Subject: Supplemental Information Regarding Seismic Hazard and Screening Report (Central and Eastern United States (CEUS) Sites) - Response to NRC Request for Information Pursuant to 10 CFR 50.54(f) Regarding Recommendation 2.1 of the Near-Term Task Force Review of Insights from the Fukushima Dai-ichi Accident

The purpose of this letter is to provide supplemental information to address the NRC staff technical questions and issues resulting from the NRC's preliminary review of the seismic hazard re-evaluation reports provided for Clinton Power Station, Unit 1, Limerick Generating Station, Units 1 and 2, Oyster Creek Nuclear Generating Station, and Quad Cities Nuclear Power Station, Units 1 and 2, as discussed at the June 17, 2014 EGC/NRC meeting. This information provides additional detailed basis and justification for the inputs and parameters used in the EGC seismic hazard re-evaluation reports supporting the EGC determination that these plant sites meet the requirements of the NRC endorsed SPID criteria (References 7 and 8) and therefore screen out from further seismic risk assessment, as discussed at the June 17, 2014 EGC/NRC meeting.

Supplemental Information in Response to NR

Figure 9

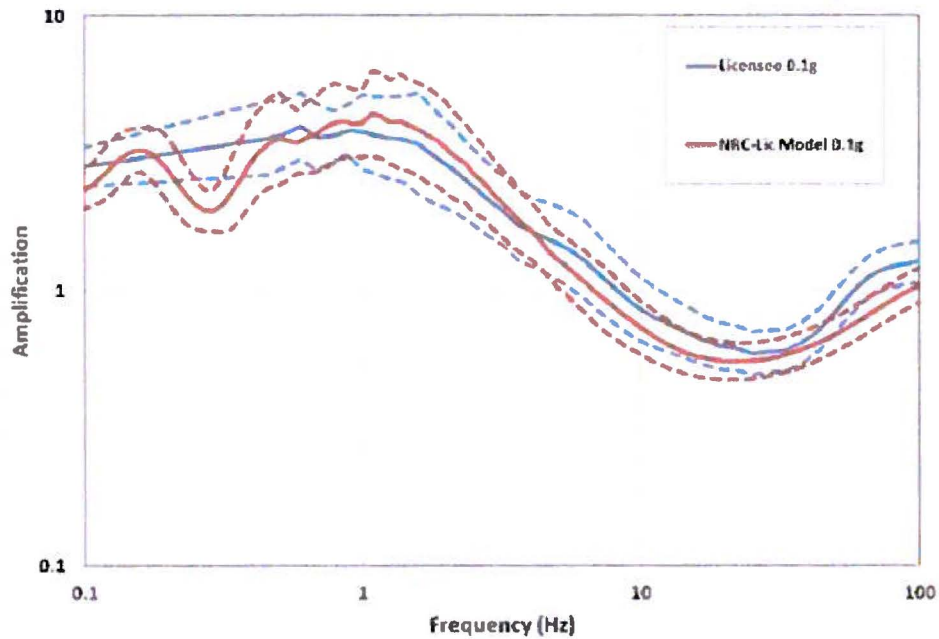
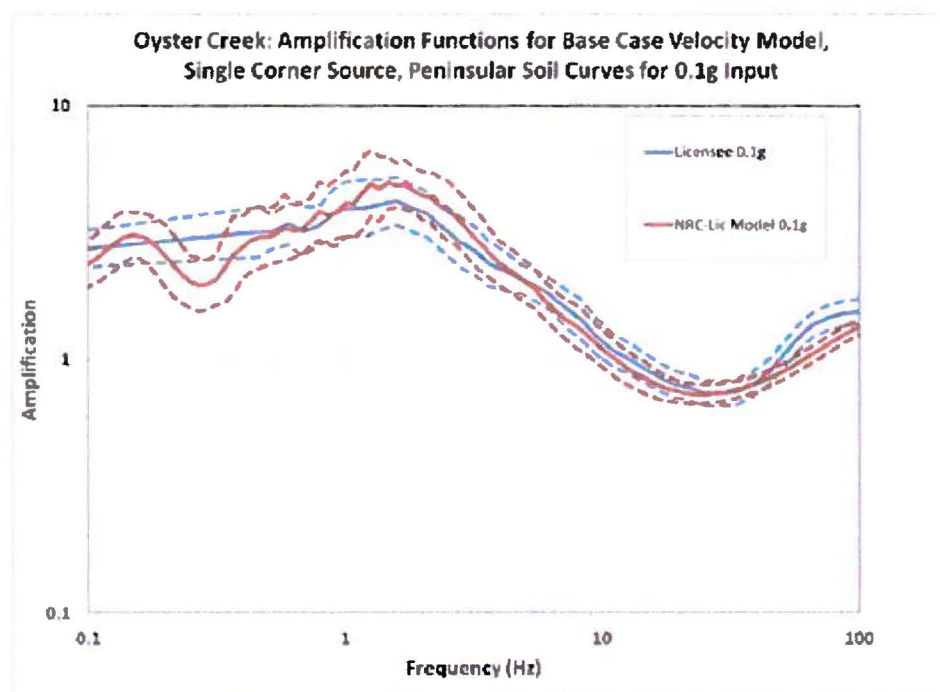
From Figure 8, it is apparent that the GMRS generated by Exelon (red) and the GMRS generated by the NRC (dashed blue) are characteristically different in shape as well as amplitude. As part of the discussion of the differences in the GMRS generated by the NRC and the GMRS generated by Exelon, the NRC also presented comparisons of the amplification functions developed by Exelon and those developed by the NRC using the inputs reported to have been used by Exelon. The comparisons of amplification functions are provided in the NRC slides from the public meeting of June 17, 2014 (Reference 31) and in Figures 9 and 10.

Based on Figures 9 and 10, it is apparent that the amplification functions developed by Exelon to generate the GMRS for the Oyster Creek site are different from the amplification functions developed by the NRC using the same inputs. As was pointed out by Exelon during the meeting of June 17, given that the amplification function axes are logarithmic, the characteristics of the amplification function differences match those of the GMRS differences. That is, in the frequency ranges where the NRC amplification functions are higher than the EPRI amplification functions, the NRC GMRS is also higher than the EPRI GMRS. The difference in shape and amplitude is in line with the differences in the amplification functions. Thus, it appears that the difference in GMRS is due to difference in development of the amplification functions.
